**PLANNING COMMISSION
CASE NO. 2020-377**

**SITE PLAN REVIEW FOR A PROPOSED BUILDING
48 CLINTON STREET**

DECISION

Re: **48 Clinton Street New Building**
Preliminary Engineering Approval - Viewpoint #20-337

Smiths Curated Building Proposed Exterior Lighting Plan

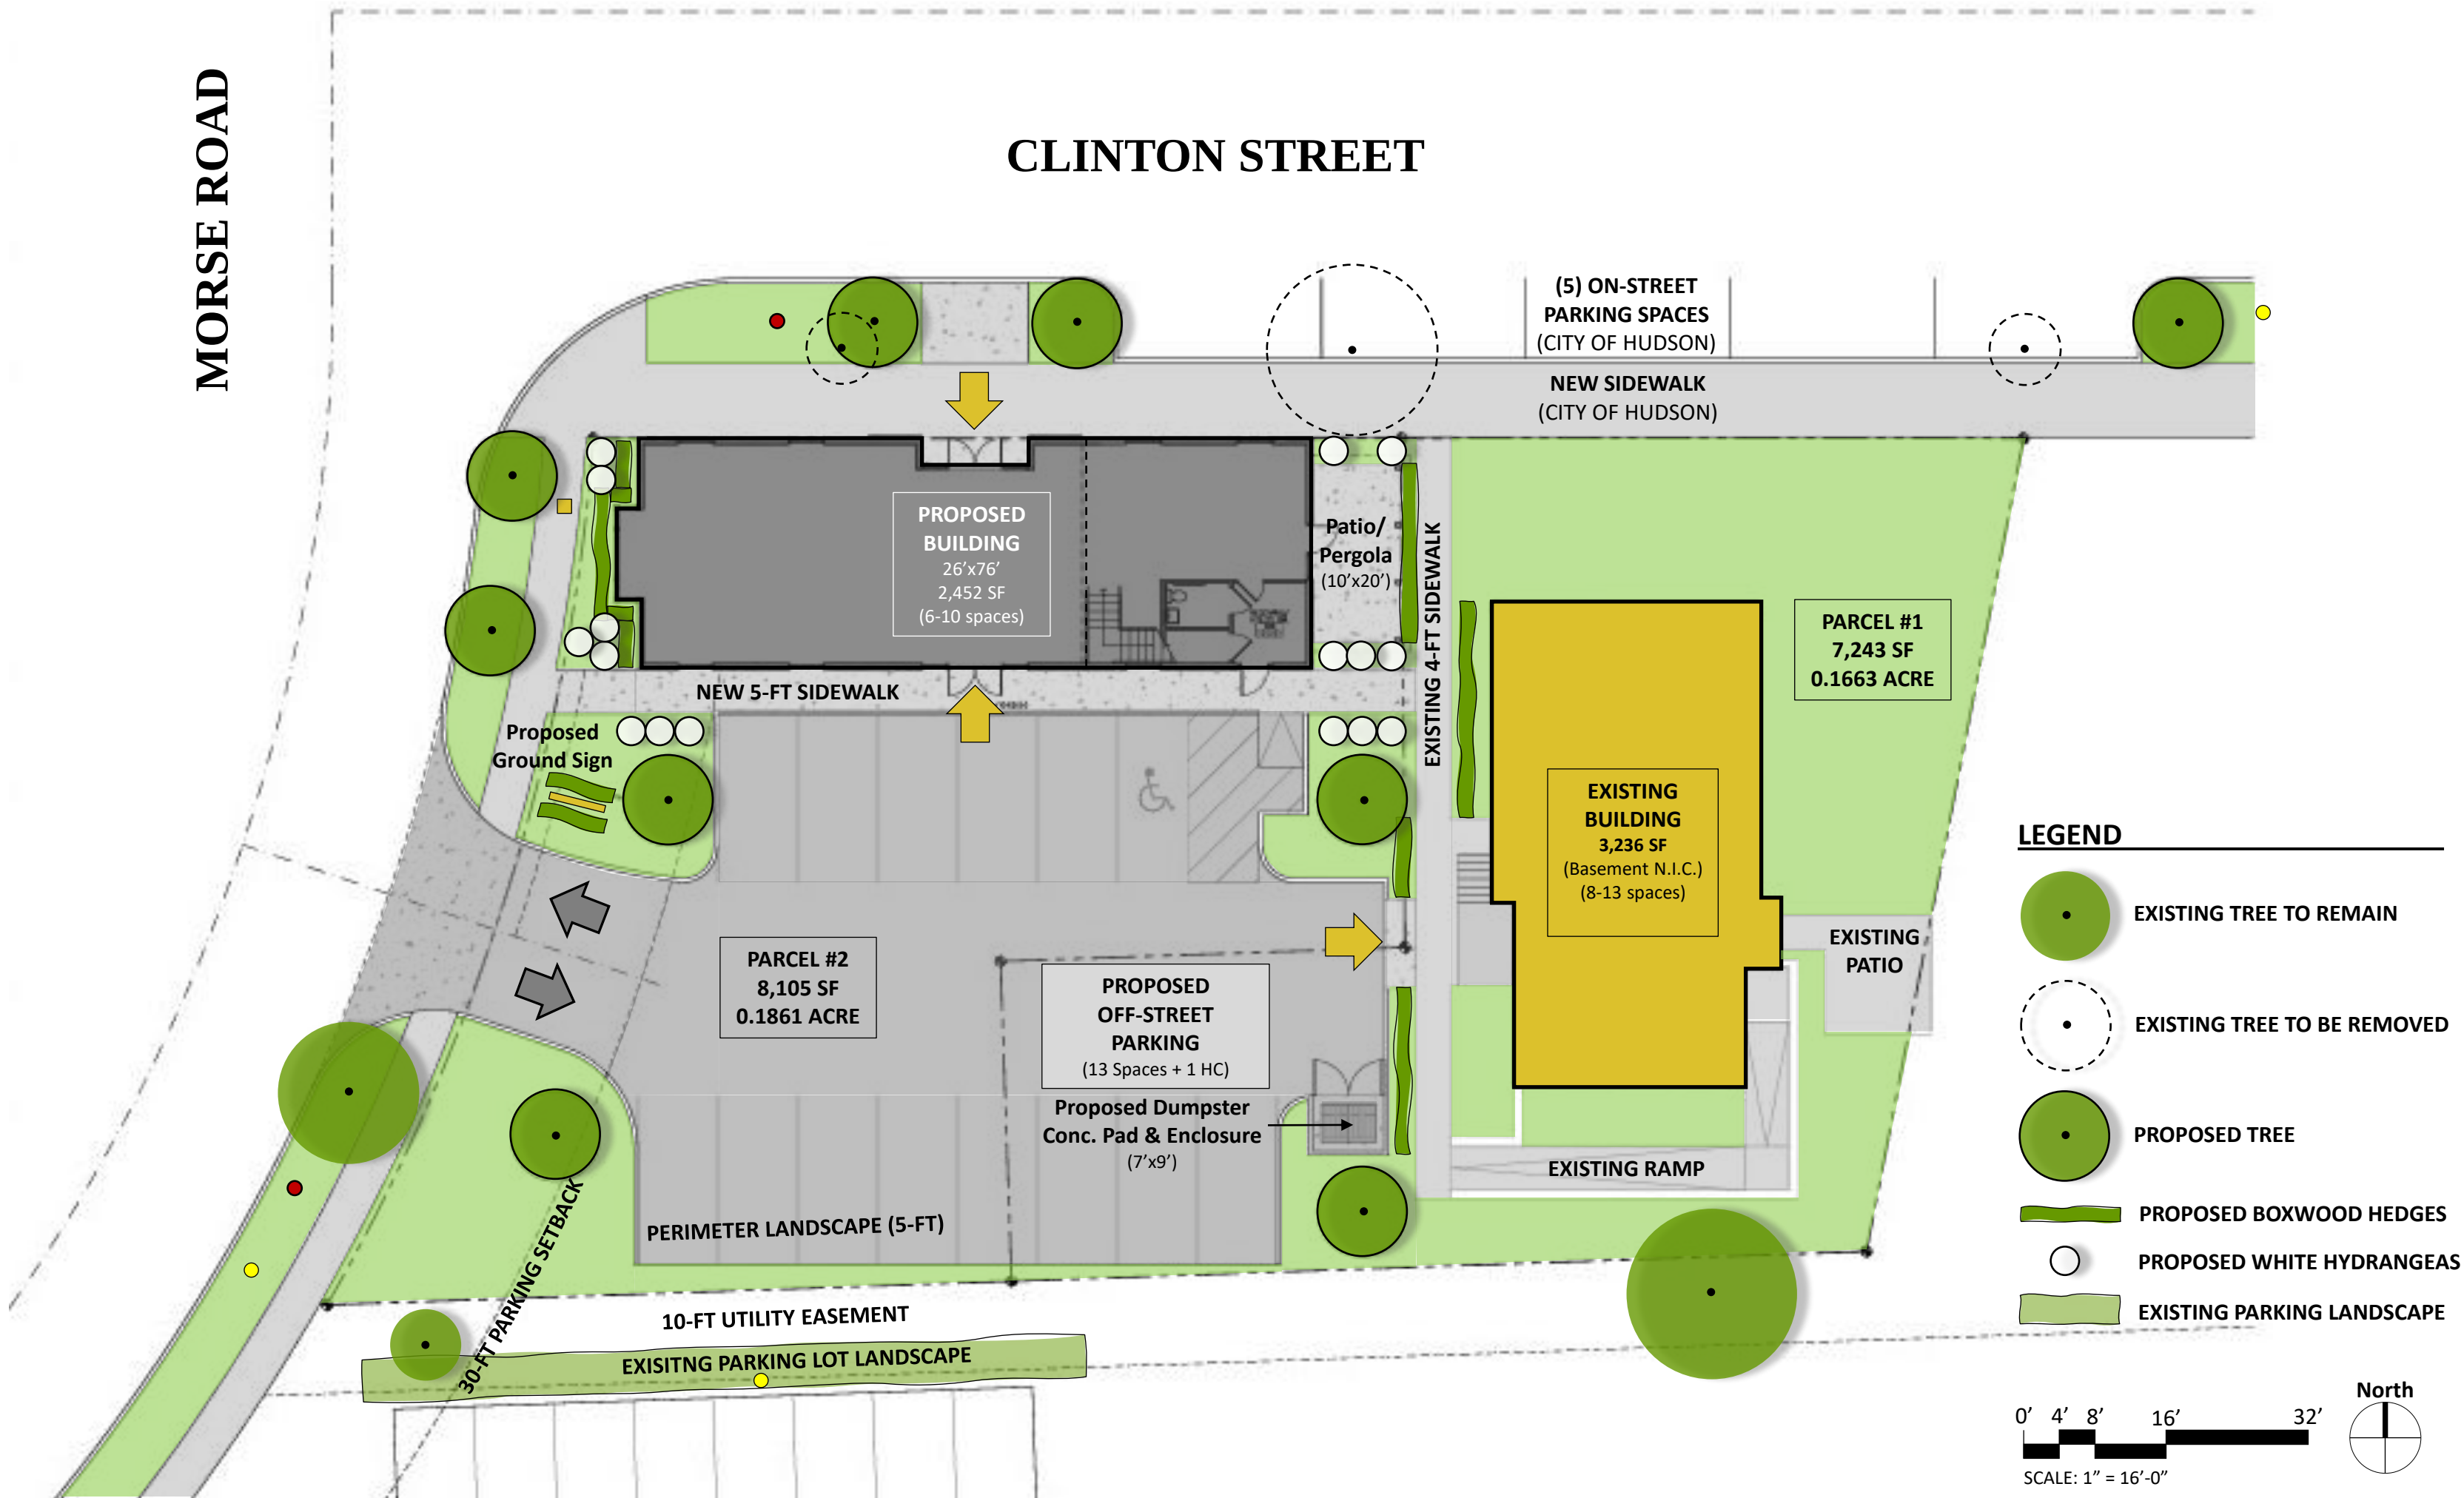
3. An exterior lighting plan and fixture spec sheets including photometrics must be submitted in compliance with applicable standards of Section 1207.18(g).

Post Development Plan for
SMITHS CURATED BUILDING
CITY OF HUDSON
COUNTY OF SUMMIT
STATE OF OHIO

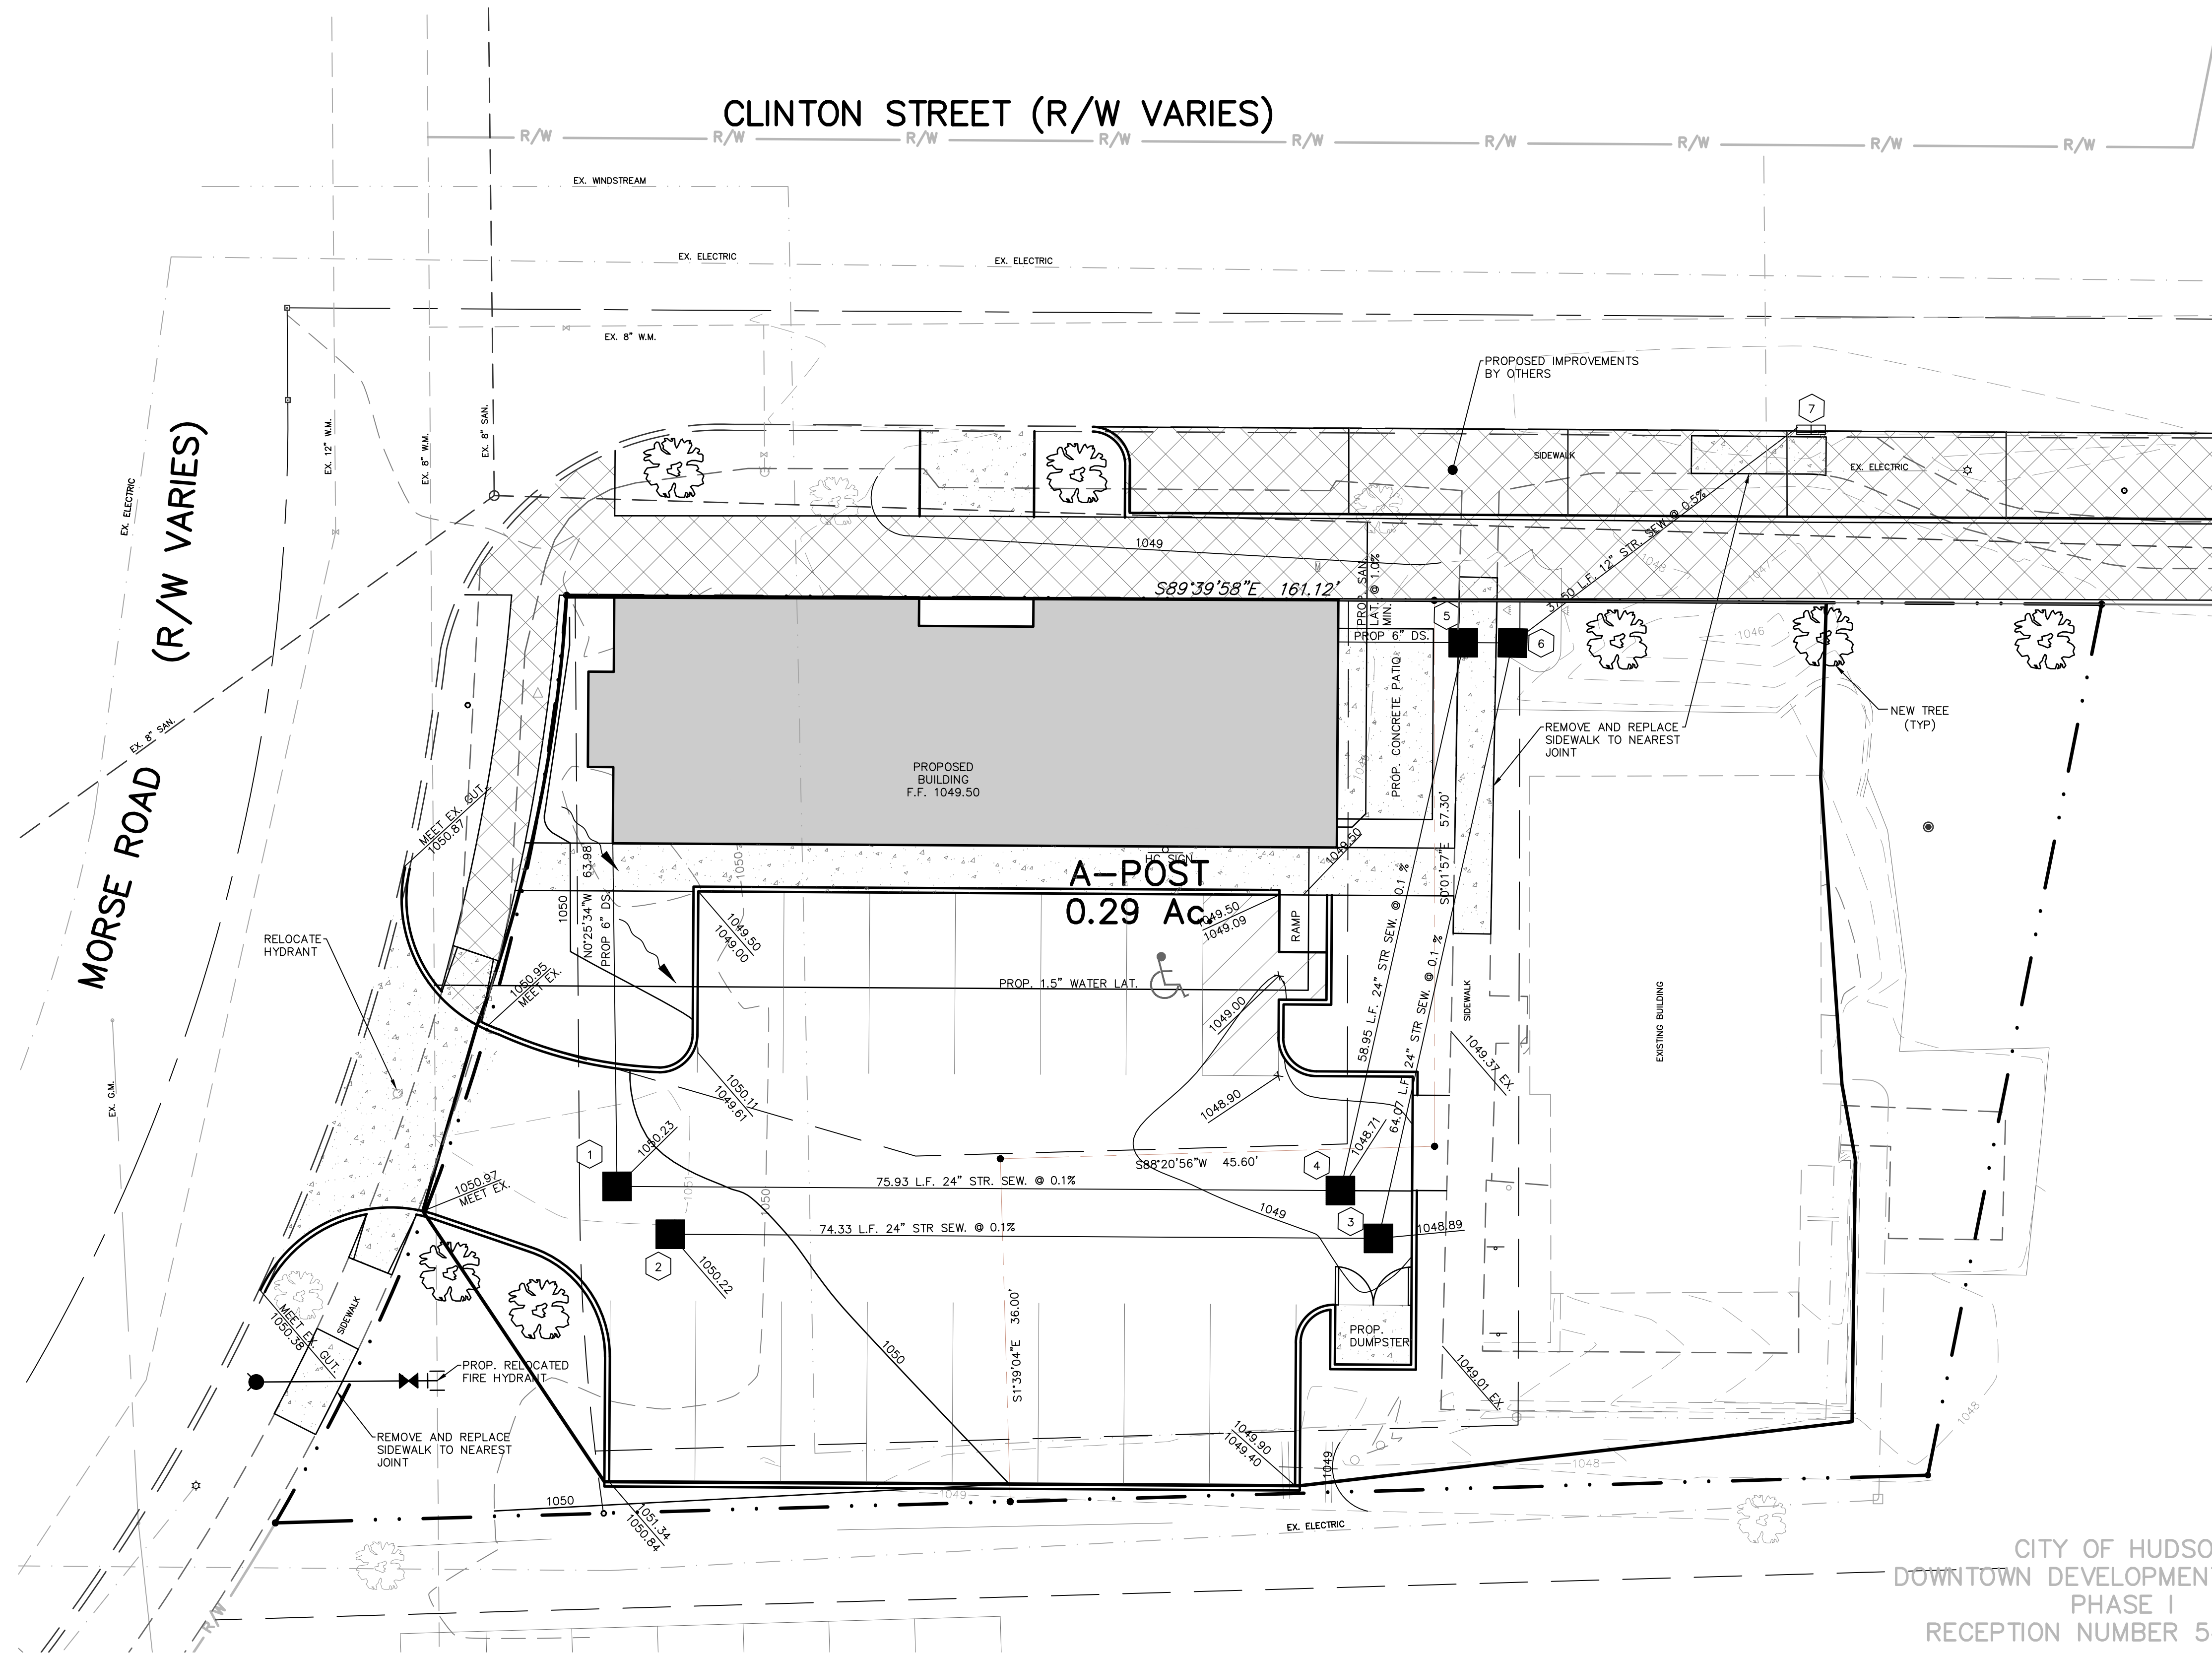
14. Submit a draft copy of the Long Term Maintenance Agreement for the underground detention pipes.
15. All storm sewer pipes from an outlet structure to a City sewer shall meet City of Hudson standards for pipe material per City Engineering standards section 4.1.A (the storm sewer from Structure #6 to #7 cannot be HDPE). Indicate all storm sewer pipe materials.
16. A 30' wide access easement to the City of Hudson shall be granted to the underground detention pipes and shall also be 30' past the 100-year water surface of the system. Show the limits of this easement on the improvement plans. This easement shall be recorded prior to acceptance of the improvements.
